**QVM Bulletin No. Q-59**

**Date: September 18, 1998**

**F53 MOTOR HOME CHASSIS CLEAR VISION AND ALIGNMENT POLICY CHANGE**

**Models Affected:** 1999 F53 Class A Motor Home Chassis

# Attachment I - 1999 F53 Caster Angle vs. Ride Height

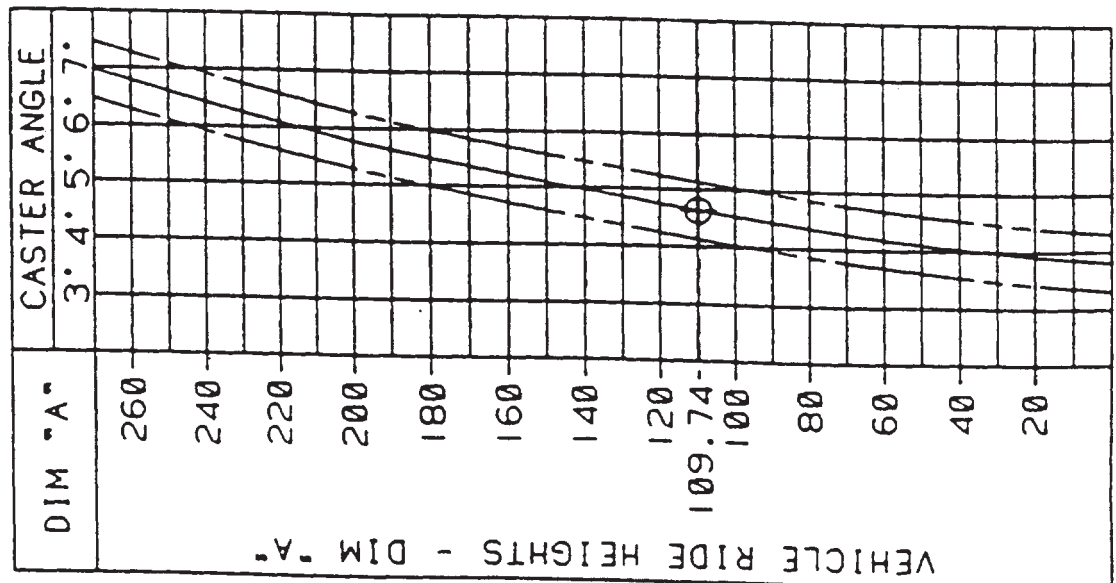
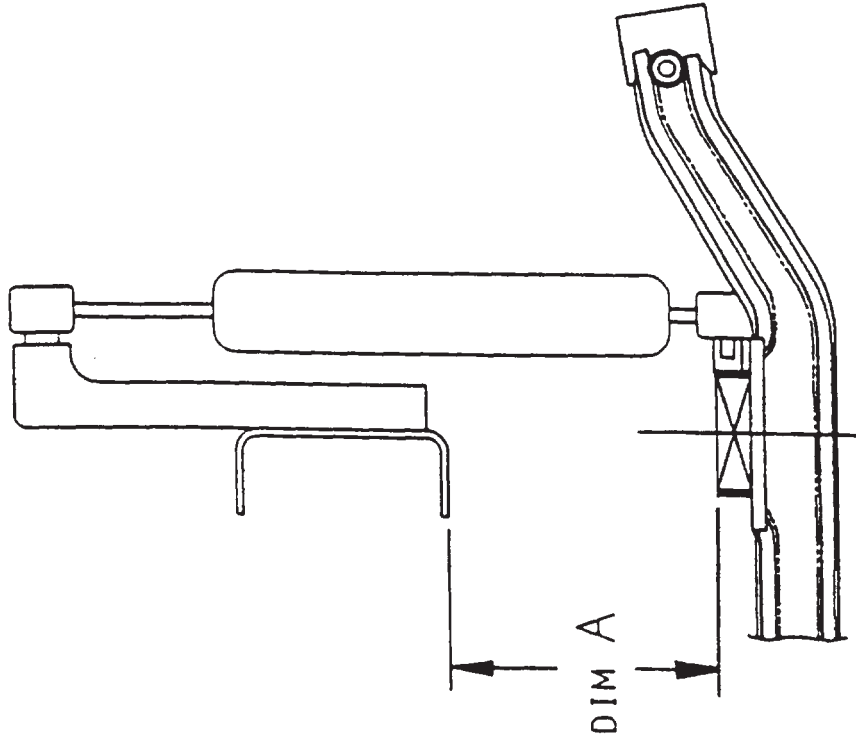
**With this policy revision, the final stage manufacturer is now responsible for adjusting toe, caster and clear vision on the completed vehicle built on the F53 chassis.**

Caster: See Attachment I for a graph showing caster at different ride heights.

Listed below are the 1999 F53 specifications for front wheel alignment and the procedure for adjusting clear vision.
